## For Thursday meeting

PLAN:  
2ND FLOOR  
BATH 2  
BATH 3

PHIL & MICHELLE WOOD  
3435 N. 140TH. CIRCLE  
OMAHA, NE 68164

SHEET: A12  
DRAWN BY: SJB  
PLAN: MAIN LEVEL  
PRIMARY WARDROBE  
REVISIONS:  
1 JUNE 26  
11 JUNE 26  
23 JUNE 26  
3 JULY 26  
10 JULY 26  
24 JULY 26  
20 AUGUST 26

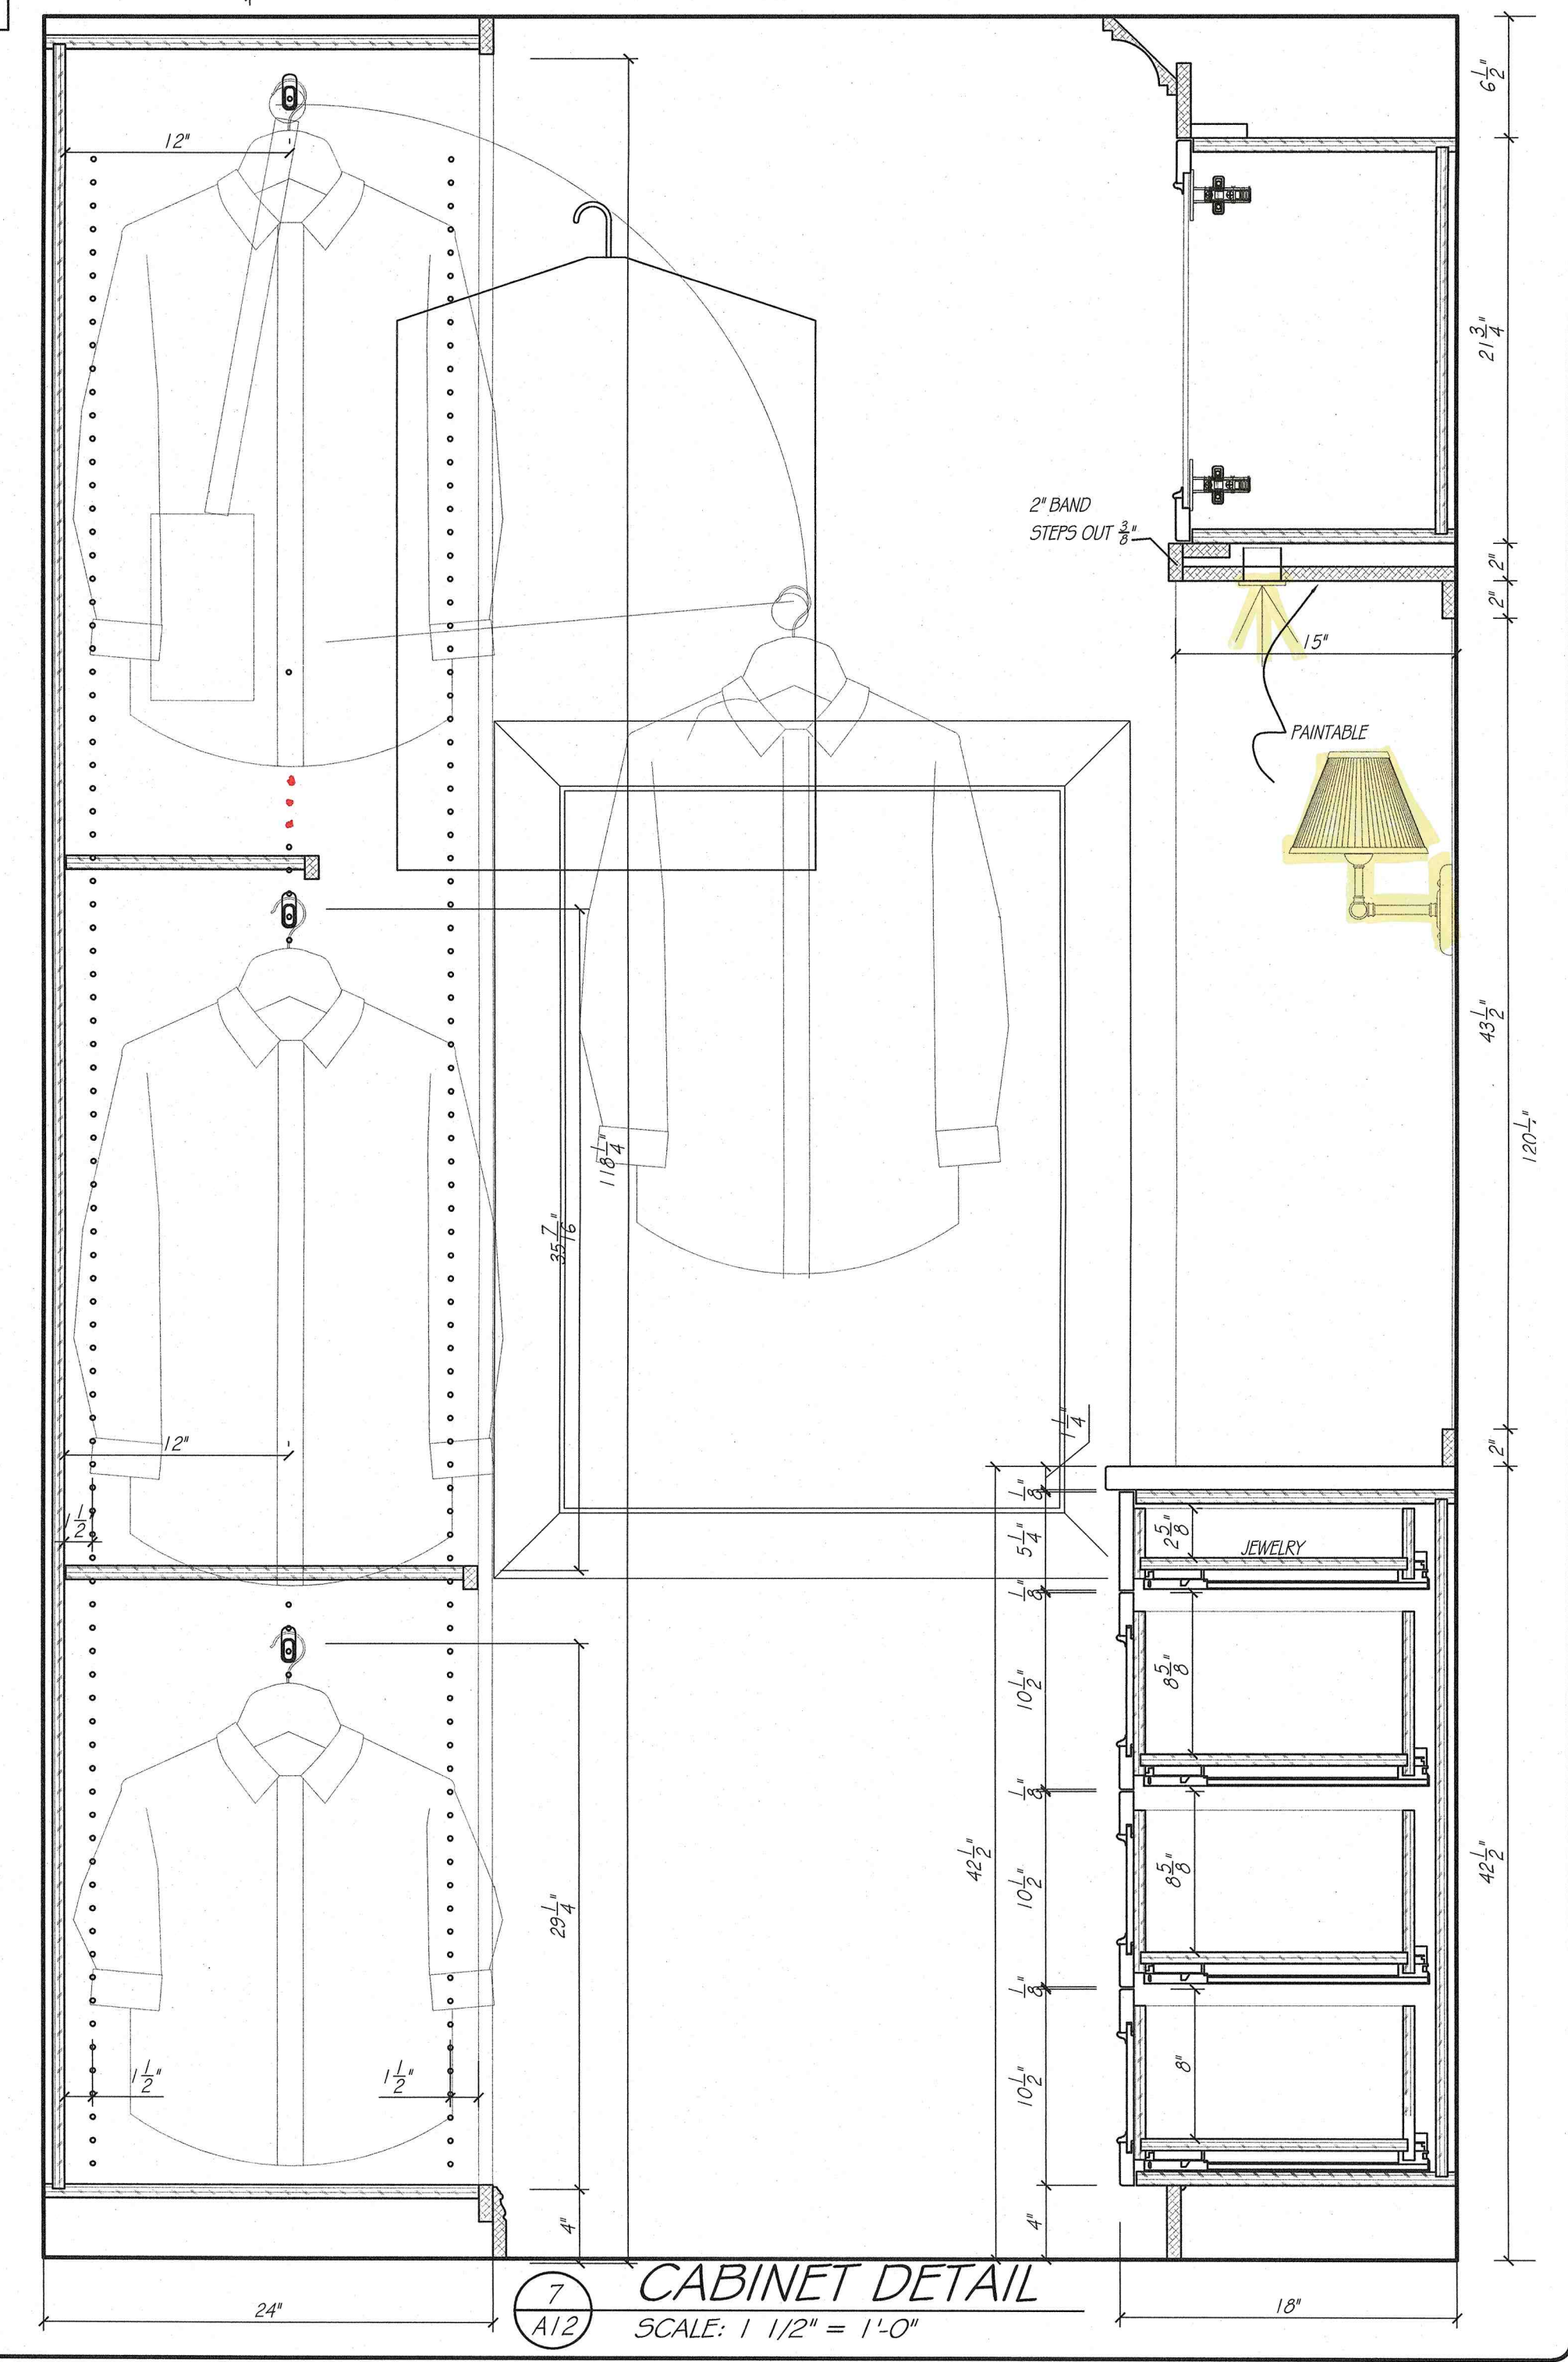
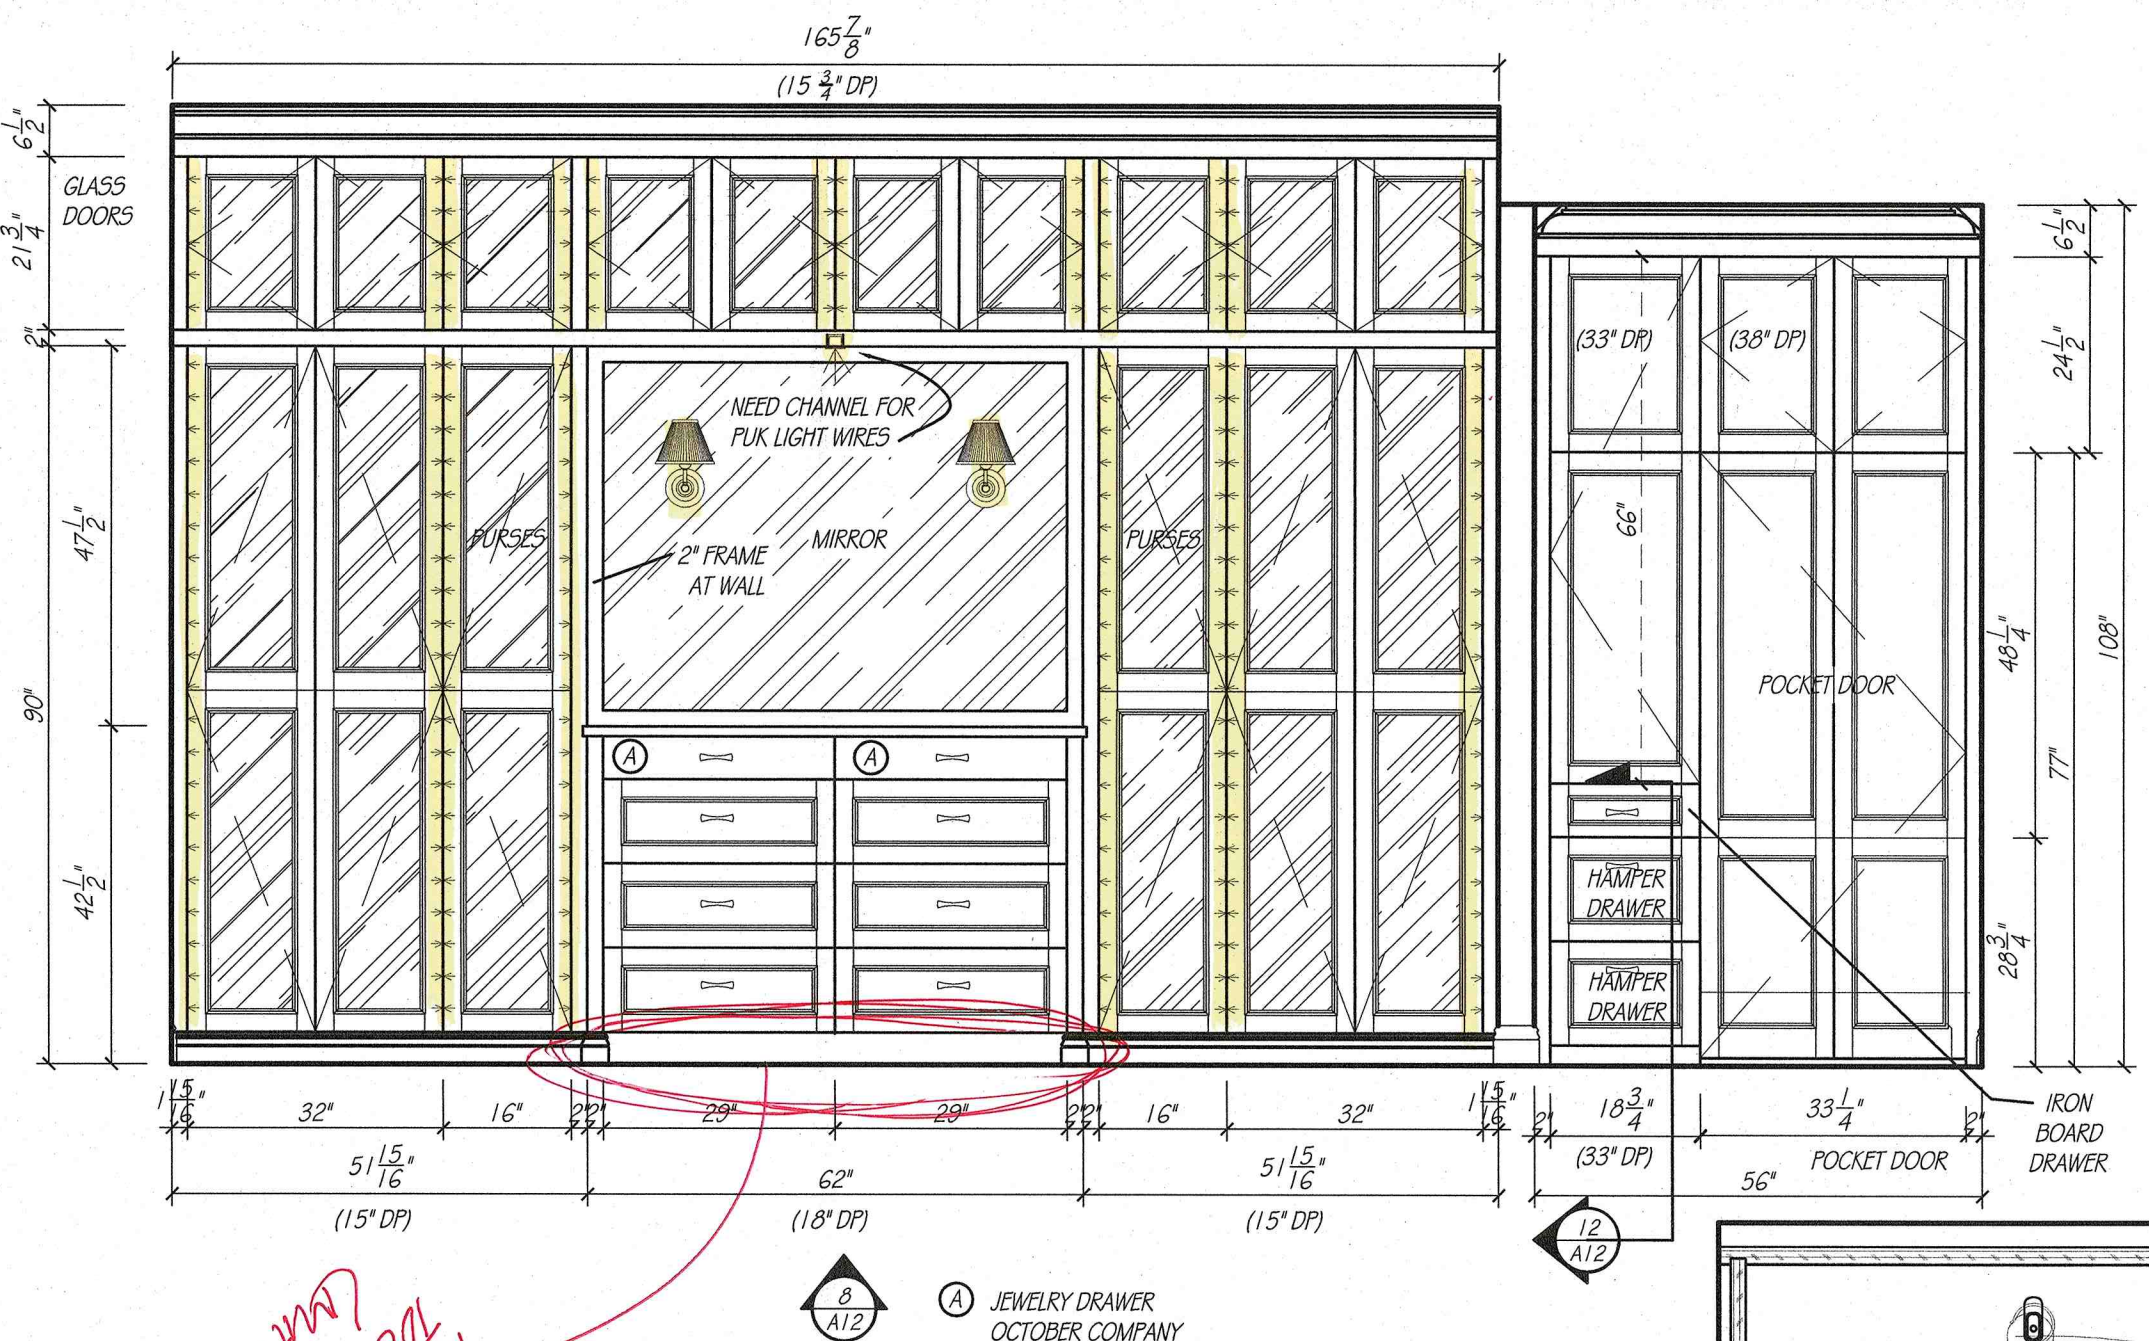
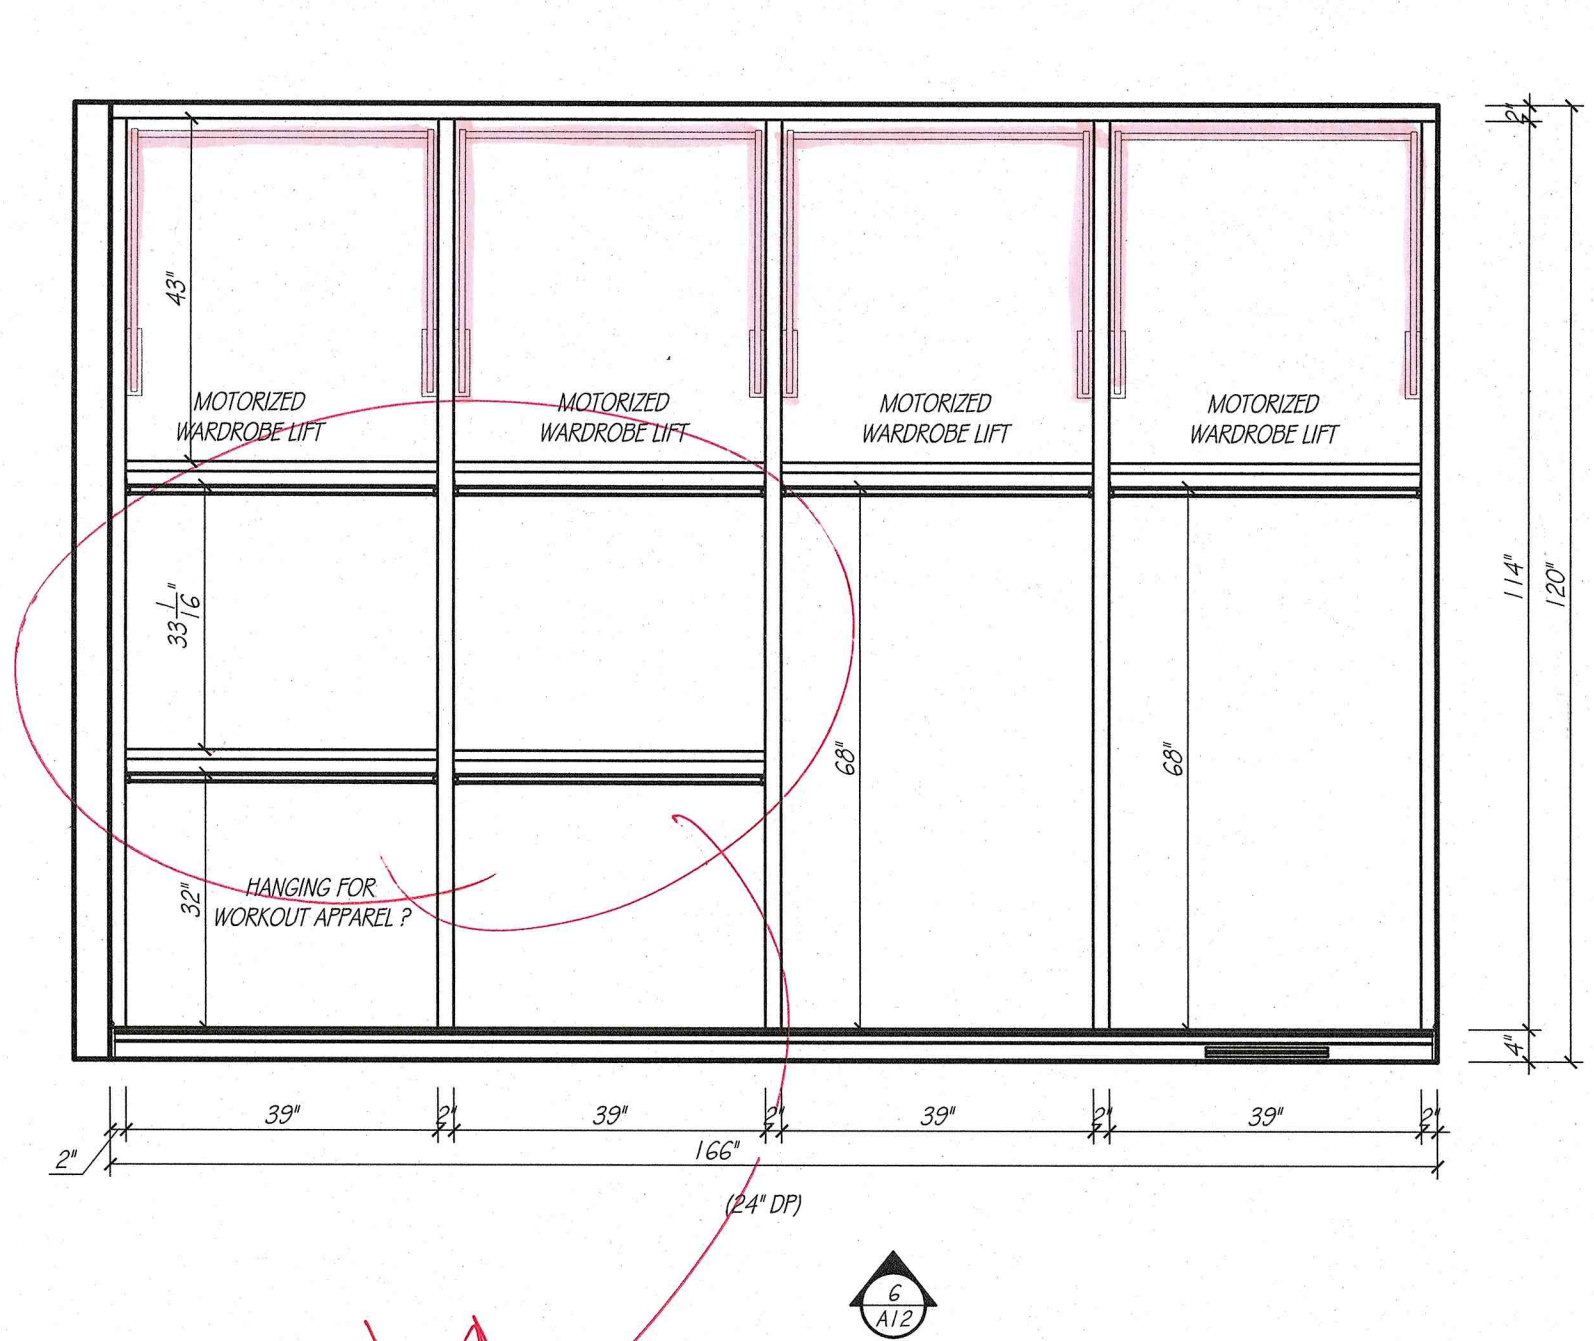
- Outlet above floor is currently where the dresser will go so it will need to be moved to either side.
- Michelle's closet -
  - Furniture toe under dresser or is it already decorative?

- Flat drawer fronts on jewelry drawers, decorative edge?
  - Need more hanging space on the two lower sections on left when walking into her closet (bars not spaced far enough apart to hang normal clothes). Need at least 32-34" in between each to allow proper hanging. Would removing shelves on top of the bars give us the space? Or, can we reduce the height of the motorized spaces above a bit?

- Ensure depth of "fancy" cabinetry is same depth. Plan shows 15" deep on the entrance side and 15 1/4" on the window side of her dresser.
  - Need to see belt holder, scarf holder, and other accessories so we can choose.

feature the w/ recess door (switch this door)

contact on site for LDD info to install (switch for use)
